# Appendix G - 10

# Yukon Pacific LNG Project

## Final Environmental Impact Statement

FERC/EIS-0071  
Yukon Pacific Company L.P.

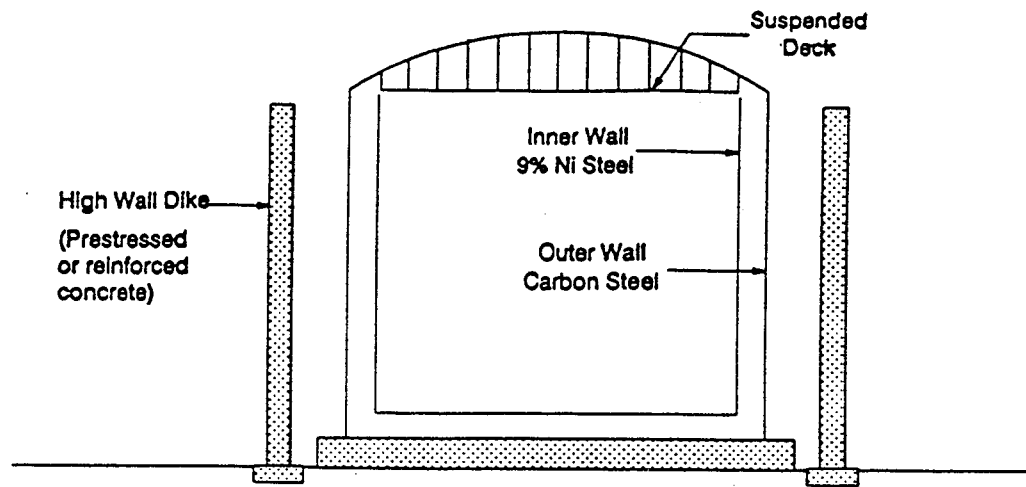
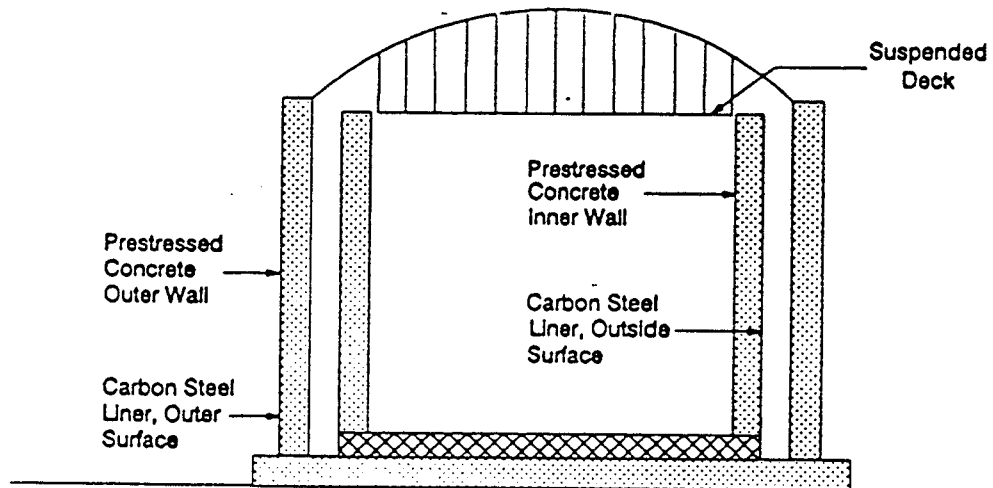
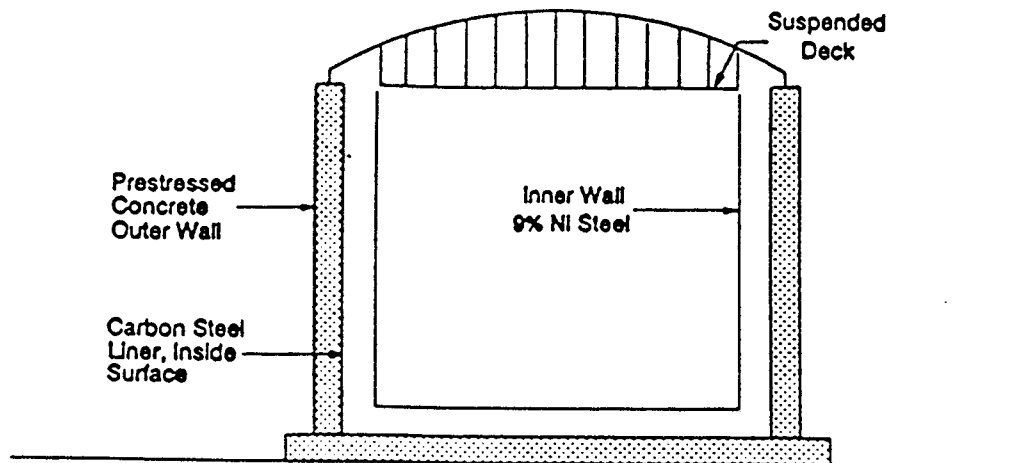
Recognition of the fact that the LNG storage tanks, together with their impoundment systems, constitute a major portion of capital expenditure for the LNG plant and that federal regulations and construction codes dictate certain minimum design and safety requirements, YPLP conducted a study in which seven types of LNG storage tanks and impoundments were identified for evaluation. Considering project requirements and site specific conditions, the field of systems to be evaluated in detail was reduced to four types. Design and estimated cost information was developed for each of these systems. Chicago Bridge and Iron Company (CBI) provided a design and relative cost study of conventional metal LNG storage tanks with low and high external concrete wall dikes (termed single-integrity since the outer tank shell of carbon steel is not designed to contain LNG spills from the inner tank should it leak or rupture). CBI also studied a metal inner wall and a prestressed concrete outer wall LNG storage tank (designated by the designers to be double-integrity since both walls are to be capable of containing LNG). Preload Incorporated (Preload) was selected to provide similar information for a configuration having prestressed concrete inner
